Project Name | BCWD Permit 22-18 Stillwater Oaks**Date** | 8/08/2023**To / Contact info** | BCWD Board of Managers**Cc / Contact info** | Jason Palmby, Fairway Estates of Grant / Scott Dahlke, Civil Engineering Site Design**Cc / Contact info** | Karen Kill, Administrator / BCWD**From / Contact info** | Camilla Correll, PE; Ryan Fleming, PE; Paul Nation, PE; John Sarafolean / EOR**Regarding** | Permit Application No. 22-18 Engineer's Report

Applicant: Jason Palmby, Fairway Estates of Grant**Permit Submittal Date:** 7/26/2023**Completeness Determination:** 08/01/2023**Board Action Required By:** 09/30/2023**Review based on BCWD Rules effective April 1, 2020****Recommendation: Consider Variance Request**

Figure 2 - Proposed stormwater facilities and offsite discharge points

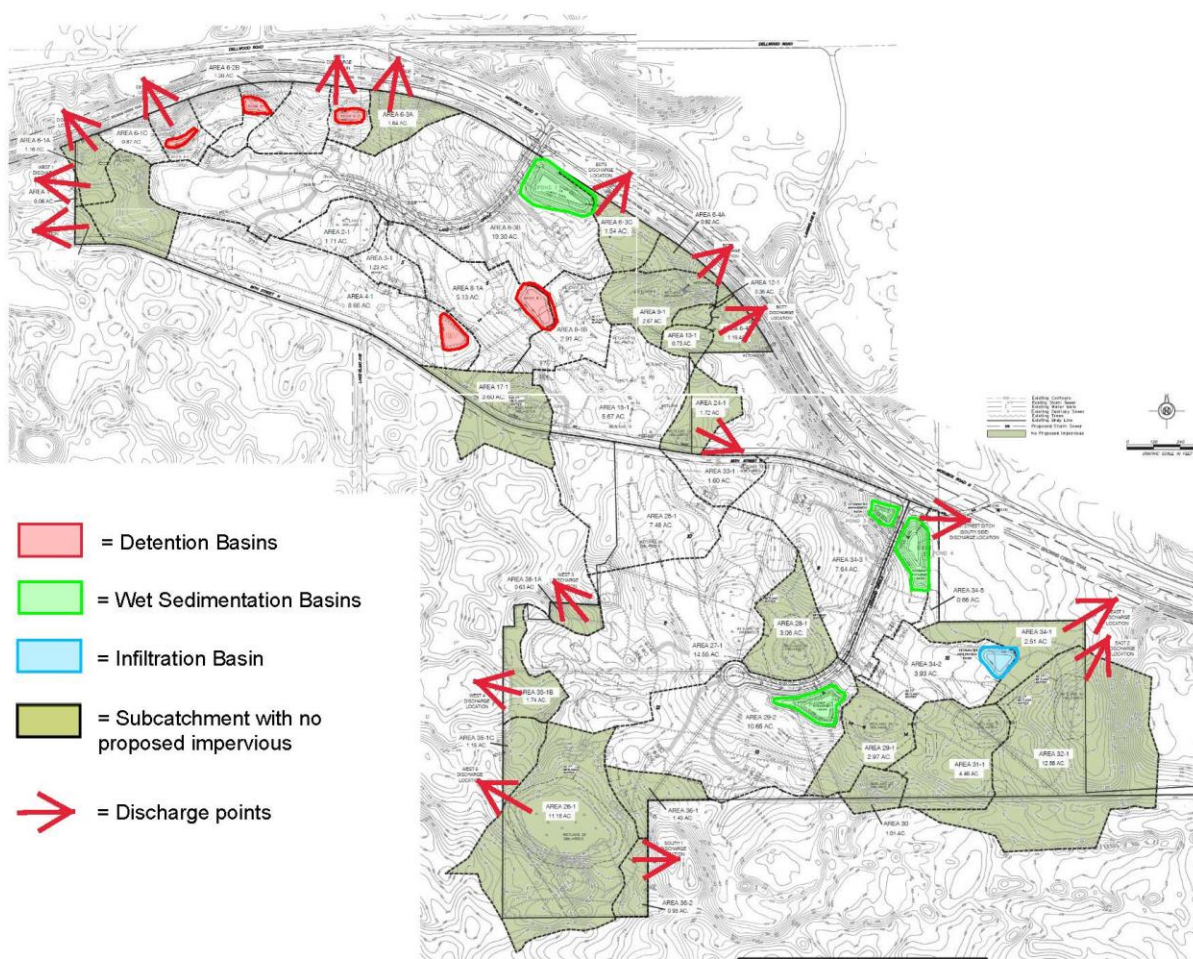
- Roadway ditches which capture runoff from the roadway and the front of the lots and route it to the stormwater management facilities.
- Four (4) stormwater management basins (wet ponds) holding permanent pools allowing pollutants and sediment to settle out, two of which will be used for stormwater harvest and reuse for irrigation of the surrounding homes.
- Five (5) detention basins (rate control/dry ponds) that control peak flow rate and reduce the effects of erosion.
- One infiltration basin.
- 12.8 acres of tree preservation and native vegetation restoration areas which will provide evapotranspiration-based volume control where infiltration is not feasible.
- The applicant is requesting a variance concerning the rate and volume requirements that is addressed in Section 10.0 – Variances.

Figure 3 – Proposed discharge to BCT2

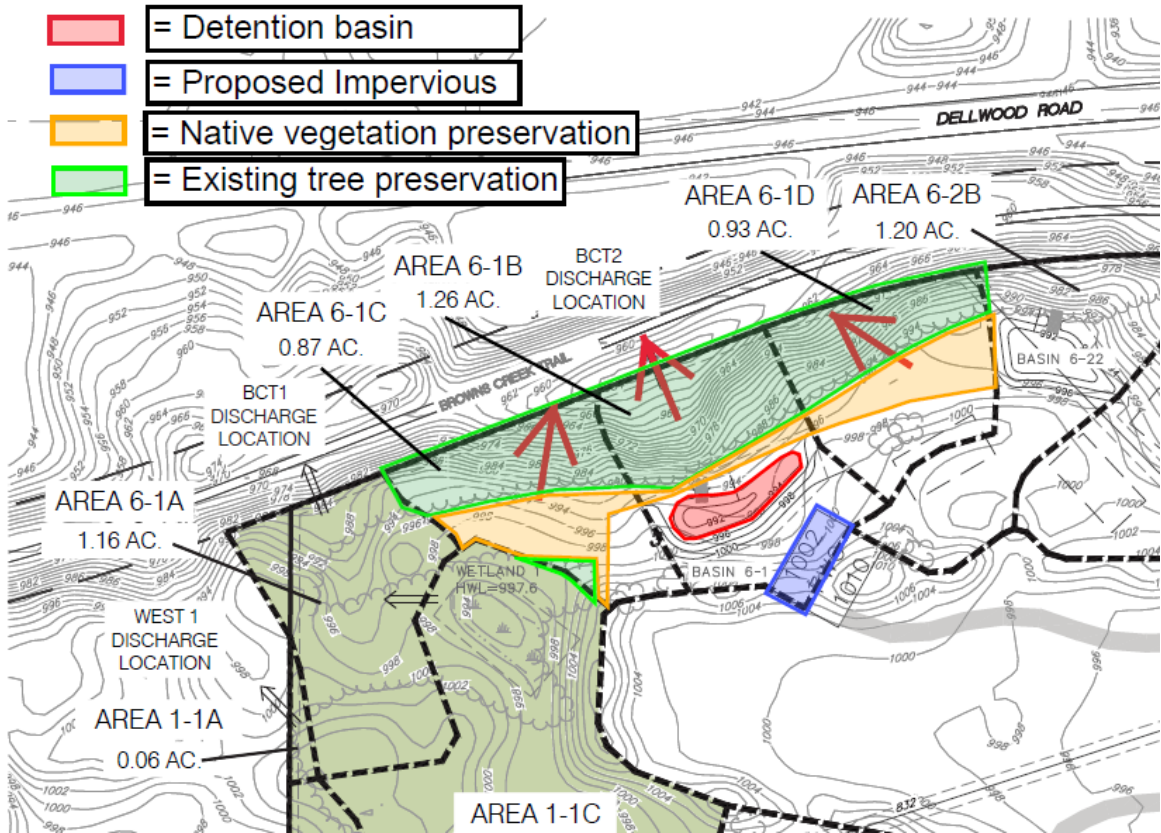
- BCT2 - This discharge point collects drainage from three subcatchments including Area 6-1C, Area 6-1B and Area 6-1D. One of these subcatchments has new impervious coverage associated with the building pad as well as a rate control pond (Area 6-1B). A significant portion of the area is being converted to native vegetation; however, this area is downstream of the rate control pond where infiltration is infeasible due to soil conditions. (Refer to Figure 3)

Figure 4 - Proposed discharge to the BCT3

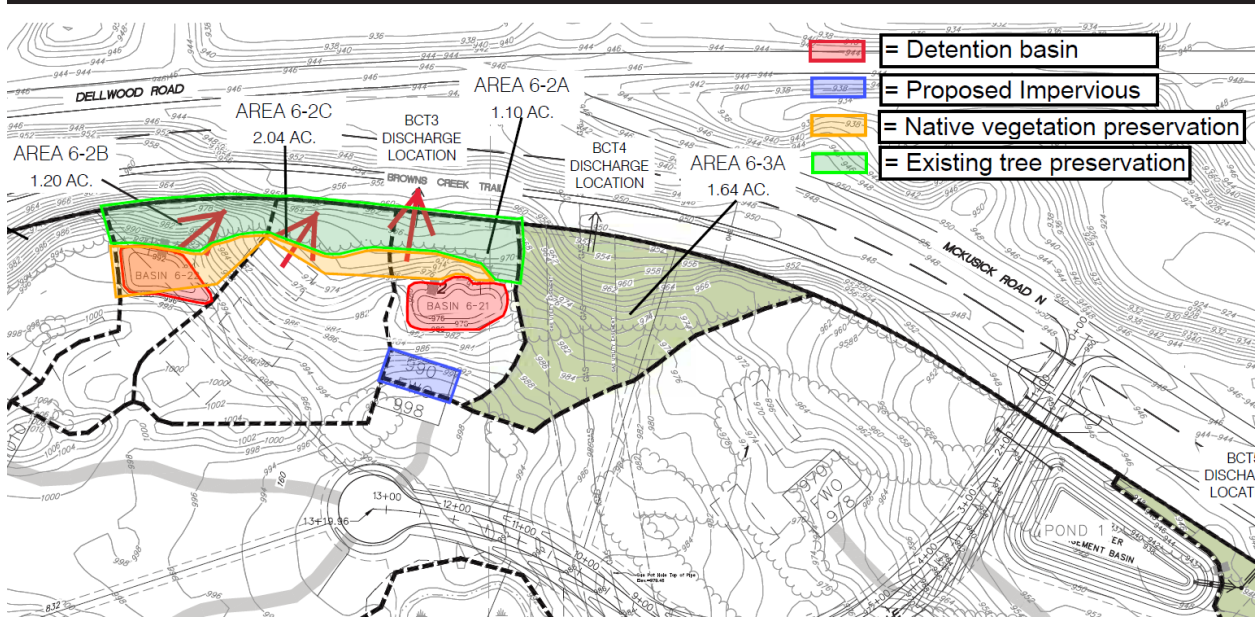
- BCT3 - This discharge point collects drainage from three subcatchments including Area 6-2B, 6-2C, and Area 6-2A. One of these subcatchments has new impervious coverage associated with the building pad. In addition, there are two rate control ponds in this drainage area that discharge to the native vegetation area. (Refer to Figure 4)

Figure 5 - Proposed discharge to the S. 88th Ditch

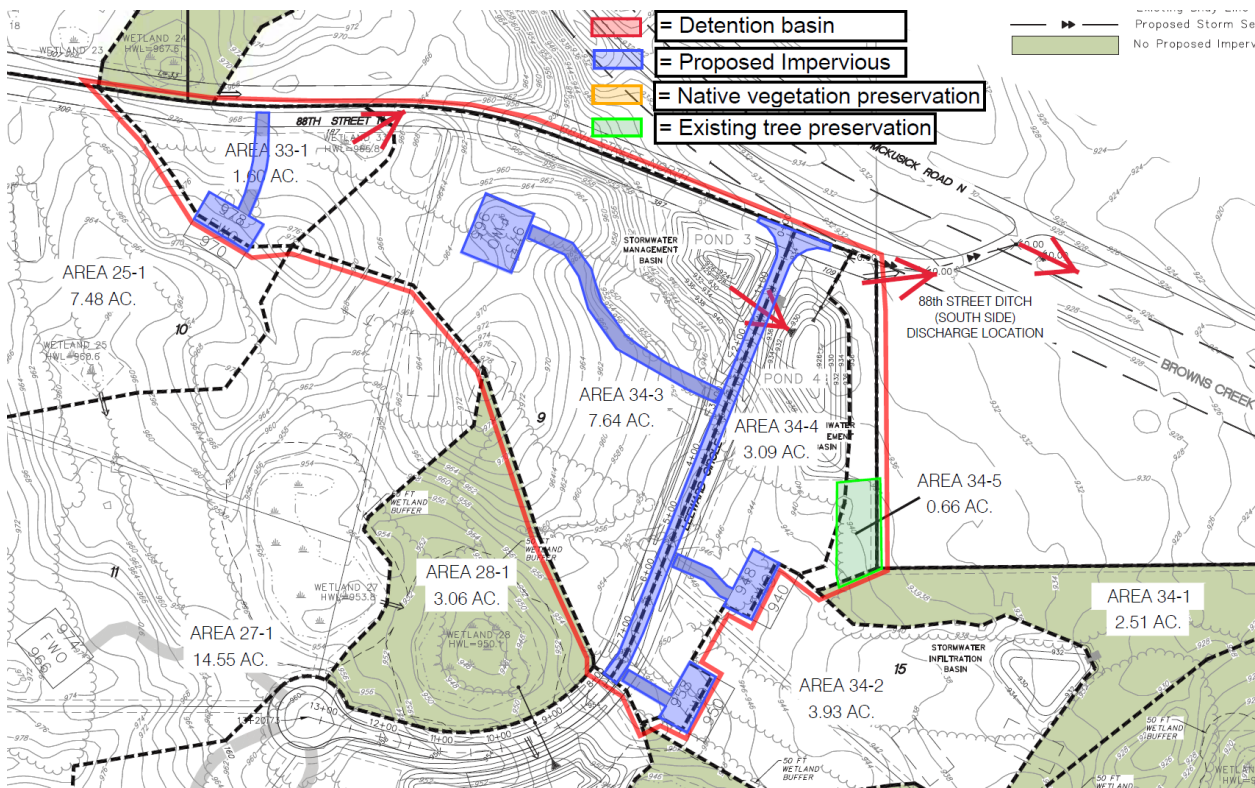
- S. 88th Ditch - This discharge point collects runoff from four subcatchments totaling 13 acres on the southern portion of the site along 88th Street North. As Figure 5 demonstrates, there is new impervious area in the form of building pads, driveways and the road which increase the amount of stormwater runoff. This additional runoff is routed to two stormwater wet ponds located at the entrance of the development. As shown in Figure 6, these ponds discharge to a vegetated swale on the south side of 88th Street North where it crosses Brown's Creek State Trail and continues to travel southeast between Brown's Creek Trail and McKusick Road. It then crosses McKusick Road onto private property where it enters a small, approximately

3,000 square foot wetland. Flow leaving the small wetland goes overland to a larger wetland complex to the northwest. The applicant did not identify what the impact of this additional volume will be to the downstream properties.

10-1. For consideration with regard to the request for a variance from the requirement in 2.4.1(a)(ii): Revise the stormwater plan to meet Rule 7.3.5 by not exceeding runoff volume for the 2-year 24-hour event leaving the site at the 88th Street discharge point and provide for District review and approval.

Figure 6 – Drainage area to 88th Street discharge point and downstream

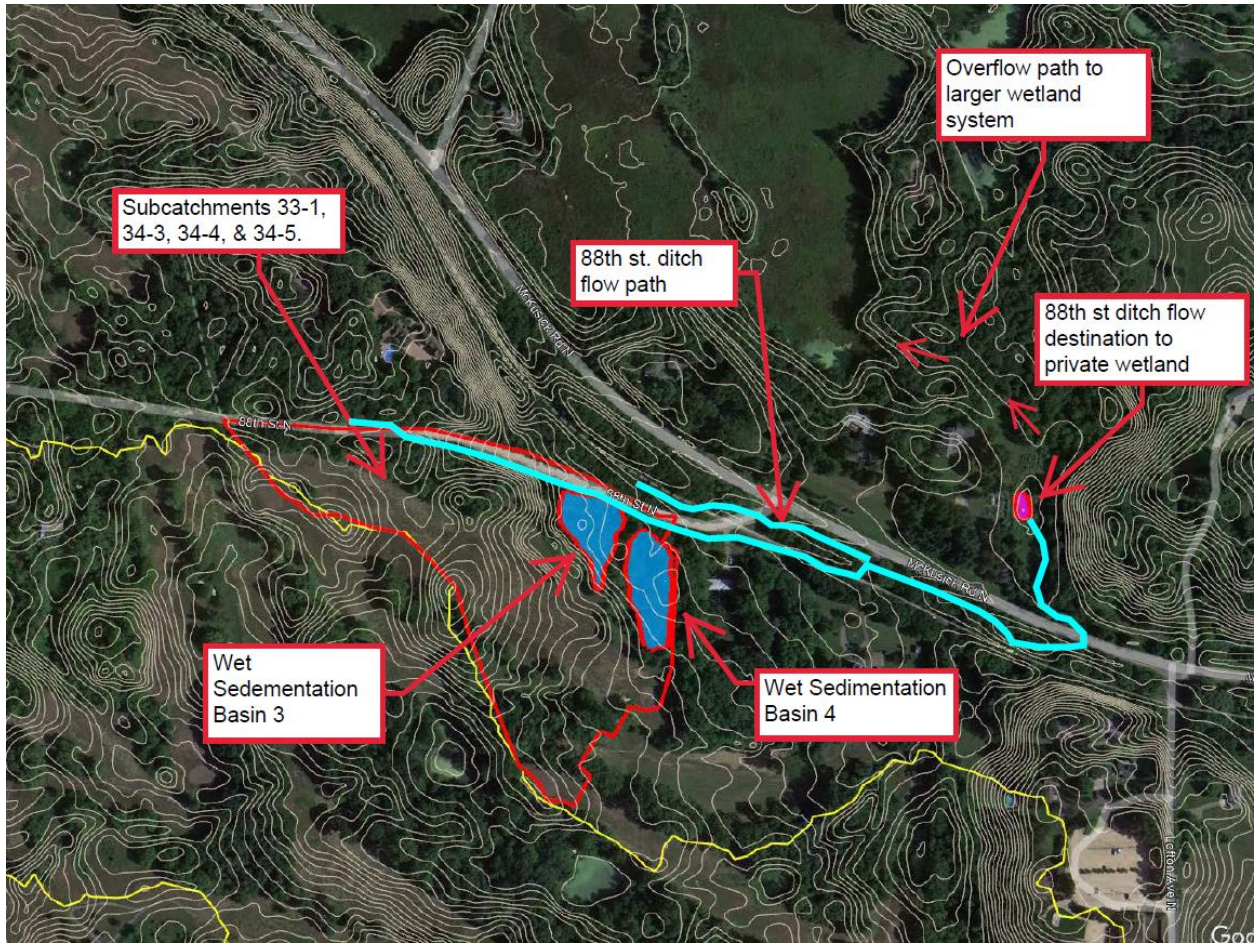
The BCWD engineer is not supportive of granting the variance to the volume control requirement, and related Rule 7.3.5 for altering surface flows, unless the stormwater plan is revised to avoid downstream impacts discharge at the 88th Street discharge location. While the total volume being mitigated via stormwater infiltration, stormwater reuse and evapotranspiration is greater than the volume currently leaving the site in total, the relevant standards apply to the downstream impact from volume increases at each discharge point, and with regard to the discharge to 88th Street North, the increase will significantly increase high water levels and flooded footprint for a downstream wetland. The cumulative volume change at each main discharge point, shown as Sub-Totals in the table, is equal to or significantly less than existing conditions *except for discharge to 88th Street North*. The increase of approximately 6,835 cubic feet of runoff for the 2-year 24-hour event will have impacts to the downstream property where more flow across their property will be experienced with greater frequency. The topography indicates that the 3,000 square foot wetland on the downstream property will bounce approximately 3 feet more than it currently does for a 2-year 24-hour event and the flood footprint of the wetland will increase by roughly 2,600 square feet on the property. This increase in flow (volume) does not comply with Rule 7.3.5 and cannot be supported by the District Engineer.
